# Access Compliance Report

## Public Rights-of-Way

### (Curb Ramps)

Intersection ID: N/A	Main Street: BROOKSVALE_ST	Cross Street: NOBLES_AV	Location: NW
ADA ID: 42FFC6D11C43	Ramp Type: Perp	Initial Pass/Fail: Fail	Overall Compliance: No
		Severity Score: 12.5

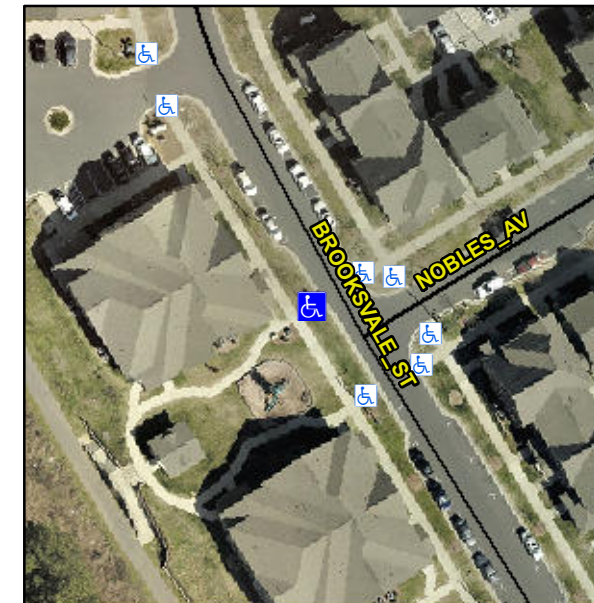
**Not Found, R304.2.2**

Compliance	Description	Data	Compliance	Description	Data
N/A	Ramp Length (in)	72.0	No	Ramp Slope (%)	8.6
Yes	Ramp Width (in)	71.0	Yes	Ramp XSlope (%)	1.9
N/A	Flare Type LT	N/A	N/A	Flare Type RT	N/A
N/A	Flare Slope LT (%)	N/A	N/A	Flare Slope RT (%)	N/A
N/A	Flare Traversable LT?	N/A	N/A	Flare Traversable RT?	N/A
N/A	Landing Length (in)	N/A	N/A	DWS Provided?	N/A
N/A	Landing Width (in)	N/A	N/A	DWS Contrast?	N/A
N/A	Landing Slope (%)	N/A	N/A	DWS Length (in)	N/A
N/A	Landing X Slope (%)	N/A	N/A	DWS Full Width?	N/A
N/A	Landing Curb? (Y/N)	N/A	N/A	DWS Offset (in)	N/A
N/A	Shared Landing?	N/A			
N/A	Gutter Ponding?	N/A	N/A	Gutter Slope (%)	N/A
N/A	Gutter Lip Ht (in)	N/A	N/A	Gutter X Slope (%)	N/A
N/A	Painted X Walk1?	No	N/A	Painted X Walk2?	N/A
	X Walk 1 Direction	To NE		X Walk 2 Direction	N/A
N/A	X Walk 1 Width (in)	N/A	N/A	X Walk 2 Width (in)	N/A
	X Walk 1 Slope (%)	4.0		X Walk 2 Slope (%)	N/A
	X Walk 1 X Slope (%)	1.6		X Walk 2 X Slope (%)	N/A

**Remove & Replace Entire Ramp.**
